IFB NUMBER: IFB 24-005/MR
IFB TITLE: Crime Lab Vehicle Search/Investigation Building Renovation
IFB DUE BY: 11:00 am CT, Wednesday, March 20, 2024
ADDENDUM NO.: 1
ISSUED (DATE): March 13, 2024

**JEFFERSON COUNTY VEHICLE
SEARCH/INVESTIGATION
BUILDING
BEAUMONT, TEXAS**

ADDENDUM No 1

A1.0

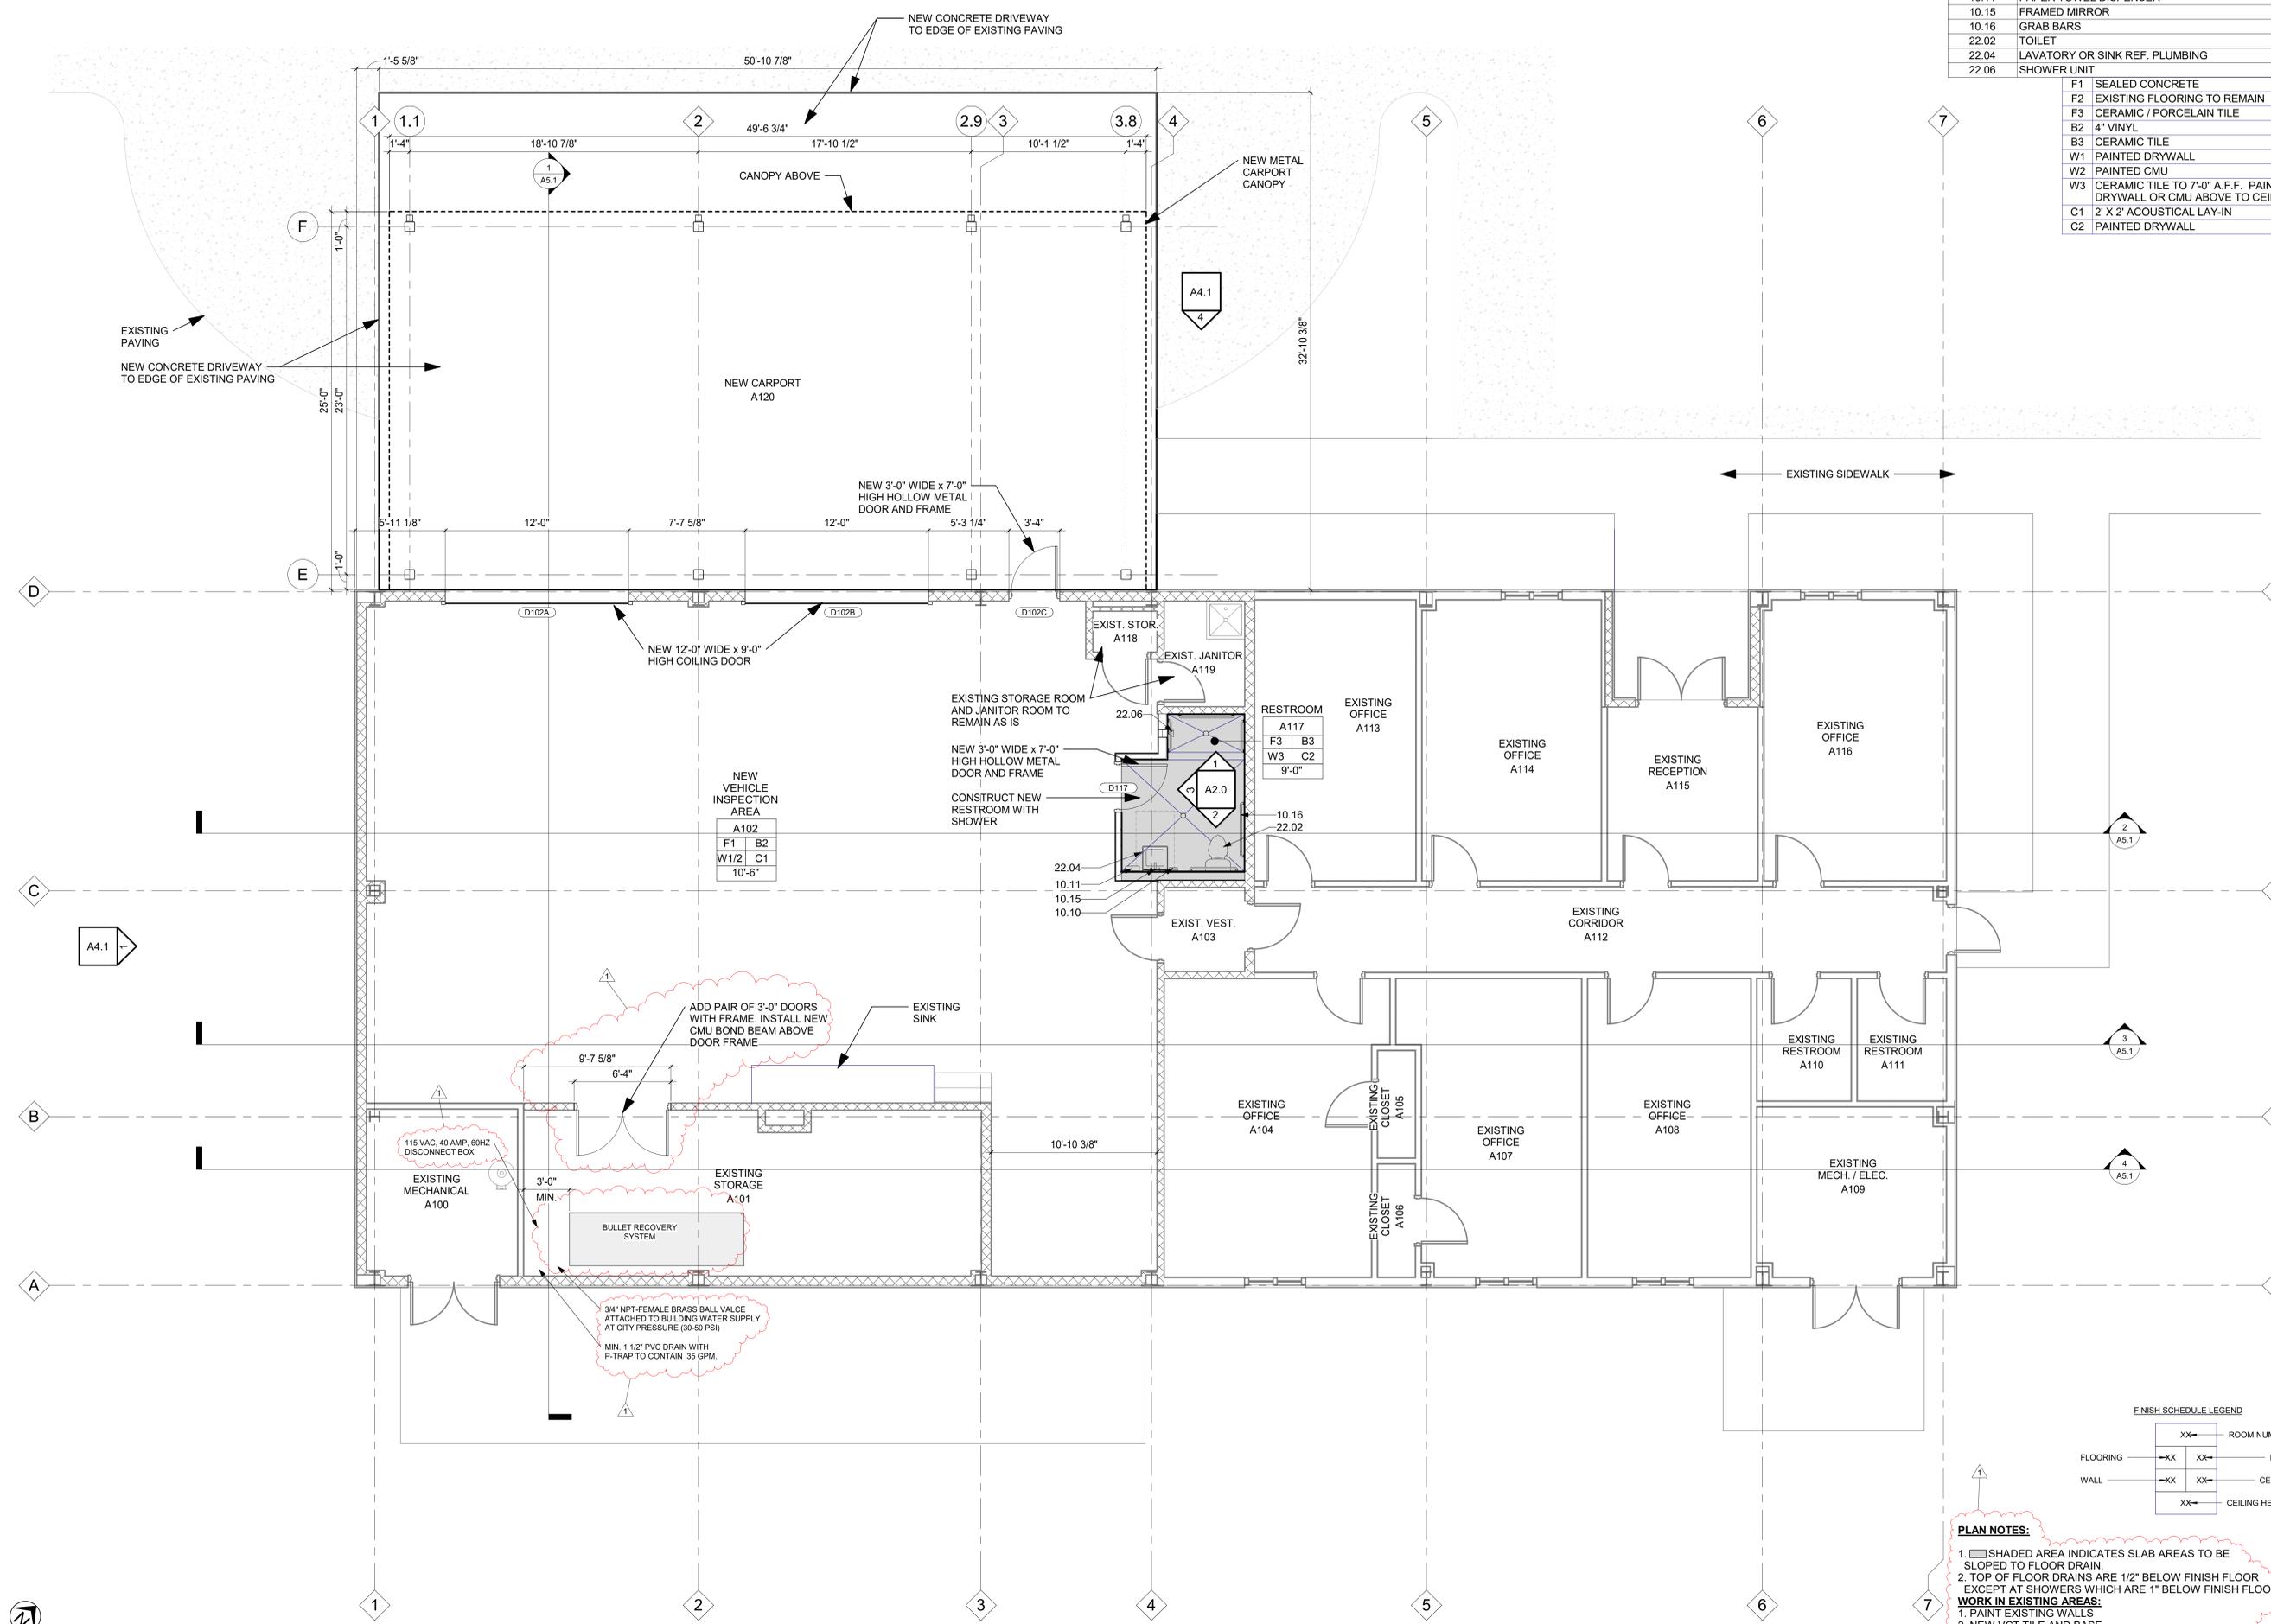
15.00	Can I get a complete "Finish" schedule for all the existing rooms?	Refer to plan notes on revised sheet A1.0.	ARCHITECTURAL	
16.00	Can we get a detail of what is required to fill the area where the in-floor scale is being removed. How deep is the area and what is below the scale?	Fill with cement stabilized sand or concrete at contractor's option. Pour 5" thick concrete topping slab flush with finished floor & use #4 rebar at 18" o.c. in both directions for reinforcing. Dowel slab reinforcing into existing foundation with 6" of embedment using an epoxy adhesive. Assume infill dimensions are 3'-0"L x 4'-0"W x 2'-0"D	STRUCTURAL

22.00	Are we painting all the hollow metal door frames in the existing office area ?	Yes.	ARCHITECTURAL	
23.00	Can we get a completed finish schedule listing the areas and surface to be painted on the exterior and interior. The specifications are confusing?	Refer to plan notes on revised sheet A1.0.	ARCHITECTURAL

- PLAN NOTES:**
- SHADED AREA INDICATES SLAB AREAS TO BE SLOPED TO FLOOR DRAIN.
 - TOP OF FLOOR DRAINS ARE 1/2" BELOW FINISH FLOOR EXCEPT AT SHOWERS WHICH ARE 1" BELOW FINISH FLOOR.
 - WORK IN EXISTING AREAS:**
 - PAINT EXISTING WALLS.
 - NEW VCT TILE AND BASE
 - NEW 2'X2' LAY-IN CEILING
 - RESTROOM FLOORS AND WALLS TO REMAIN AS IS

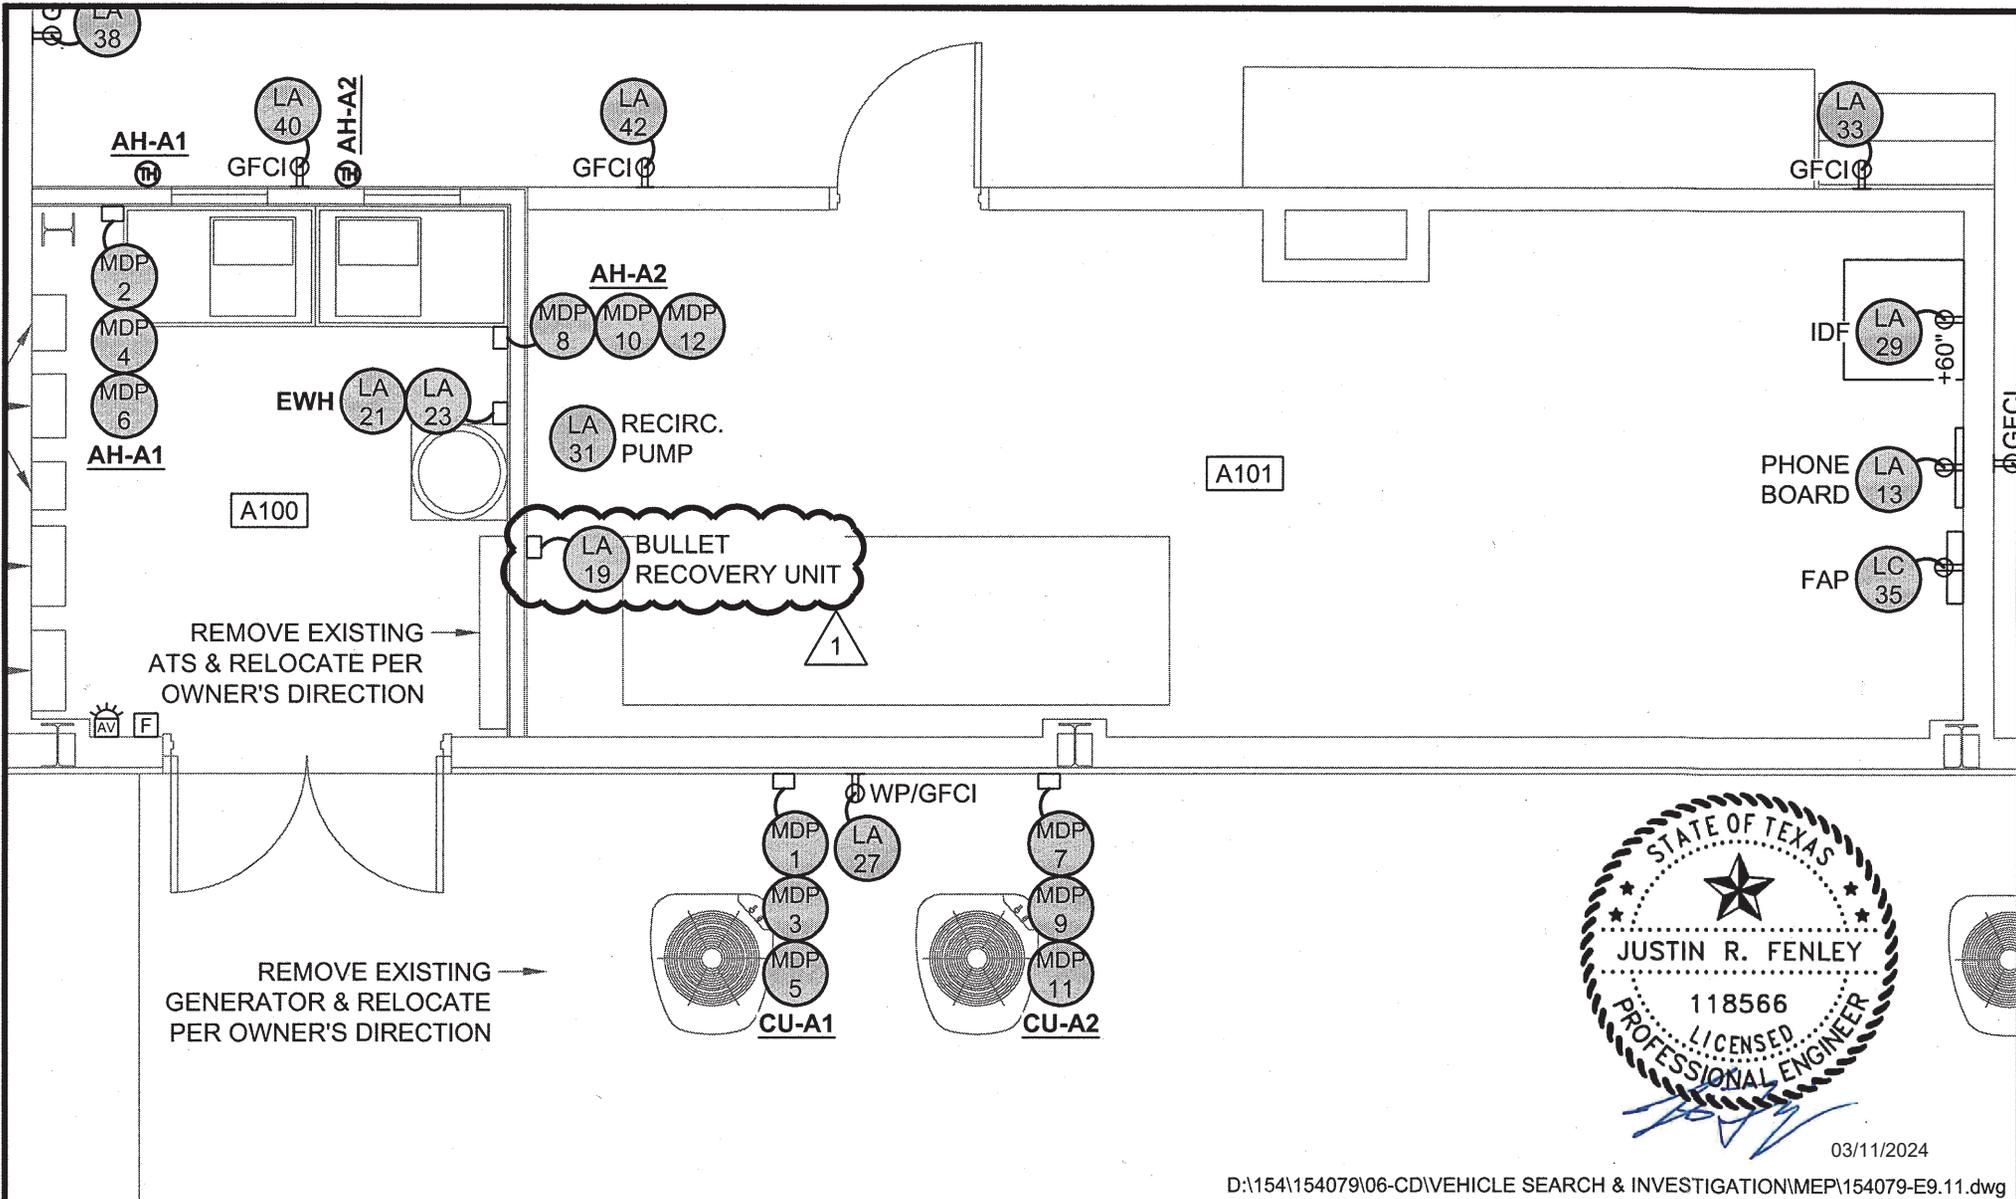
26.00	After reading the plans and specs. I am unclear ,are we removing the existing fire alarm and replacing it with a new system. or are we just modifying the existing system?	Refer to sheet E9.11 that states to provide new fire alarm system. Sheet E9.11 and E9.21 show recommended fire alarm device locations. Refer to specification section 27 60 10 for all requirements for a new fire alarm system.	MEP

28.00	Can we get better clarification on the fire alarm and IT requirements.	See comments on item #6 and #7 above.	MEP	
29.00	Would all the lighting be demoed and replaced?	All existing light fixtures shall be removed and replaced with new. Refer to sheet E9.21. Demo of the existing electrical system shall include but not be limited to the following: - Modification of existing panel "MDP" to panel schedule shown on sheet E9.31. - Modification of existing panel "LA" to panel schedule shown on sheet E9.31. - Modification of existing panel "LC" to panel schedule shown on sheet E9.31. - Removal of existing panel "LB" shown on sheet E9.11. - Removal of all existing lighting and replacement with new as shown on sheet E9.21. - Removal of all existing electrical branch circuits and devices and replacement with new as shown on sheet E9.11. - Removal of existing network and phone infrastructure and cabling and installation of new as shown on sheet E9.11, E9.21, and specifications sections. - Removal of existing fire alarm system and devices and installation of new as shown on sheet E9.11, E9.21, and specification sections. - Removal of existing automatic transfer switch and generator and delivering to Owner as shown on sheet E9.11.	MEP

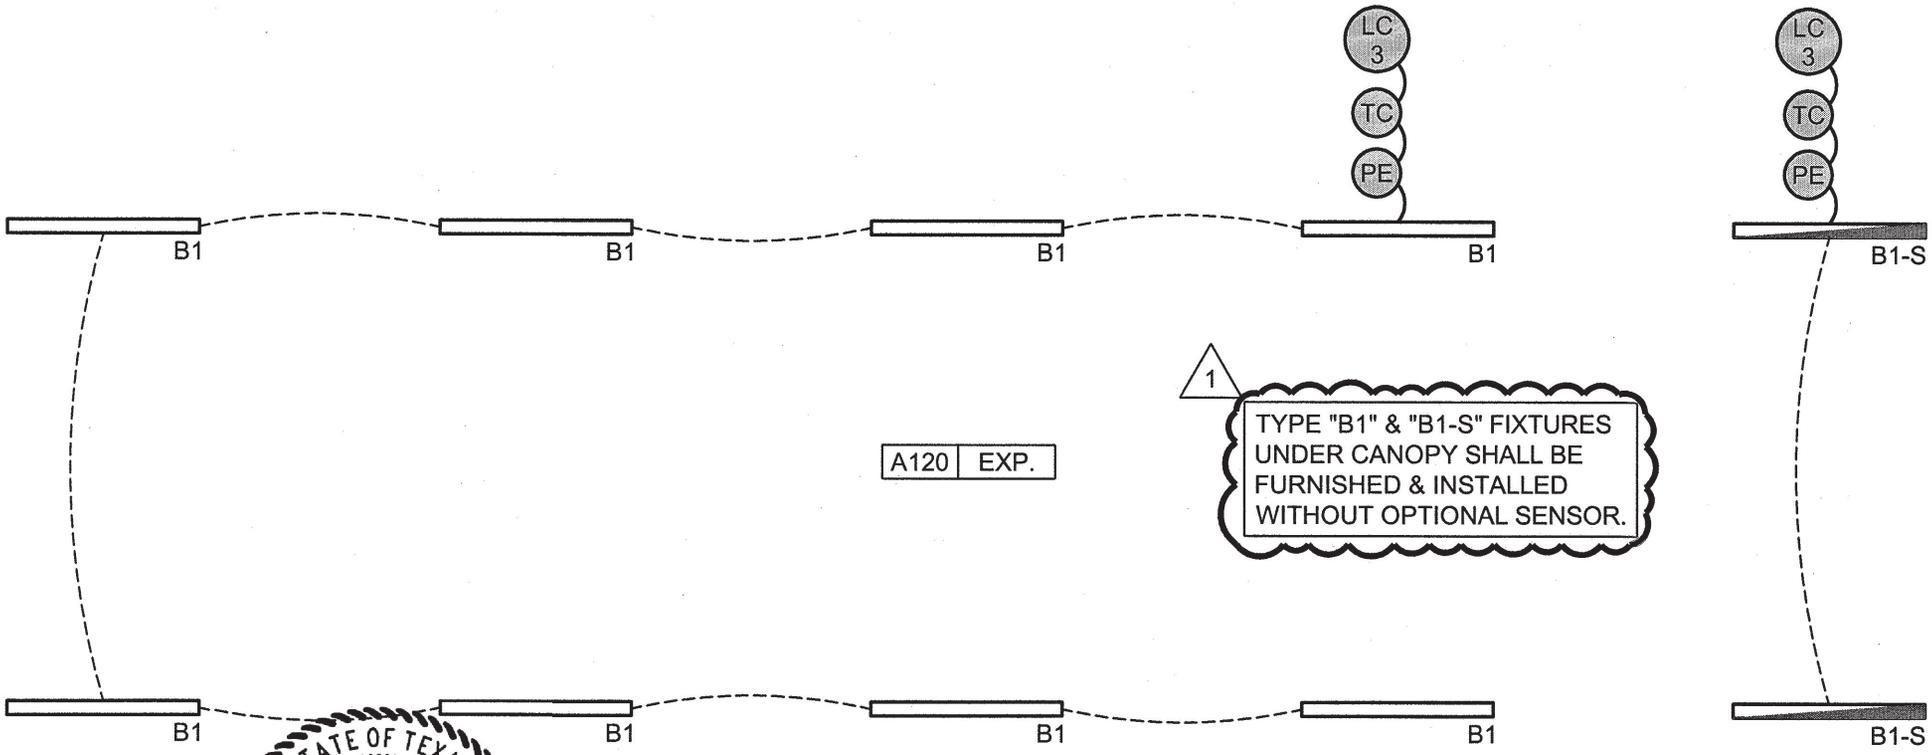
6.00	What does the circle PC in the hall between the garage and the offices represent? Was it supposed to be an LC?	This is referring to branch circuit for the light fixture in room A103 on sheet E9.21. The branch circuit shall be (LC-1).	MEP
